February 22, 2016

Subject: 57 way female connector

57 Way Slide Retention Feature

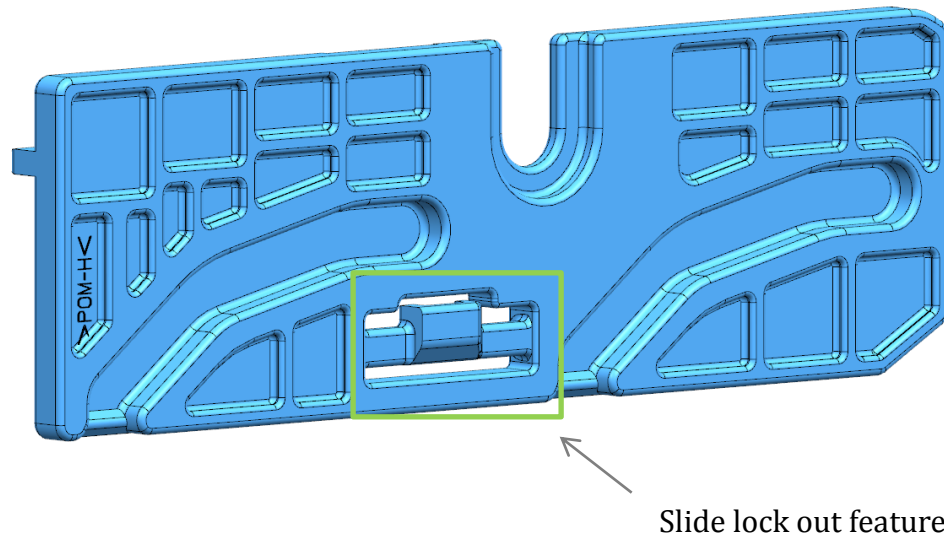
DCS Component Engineering has implemented one change to the current 57 way female connector. The lever lock out features on the slides have been revised to prevent the features from being damaged if the lever is activated without the mating device present.
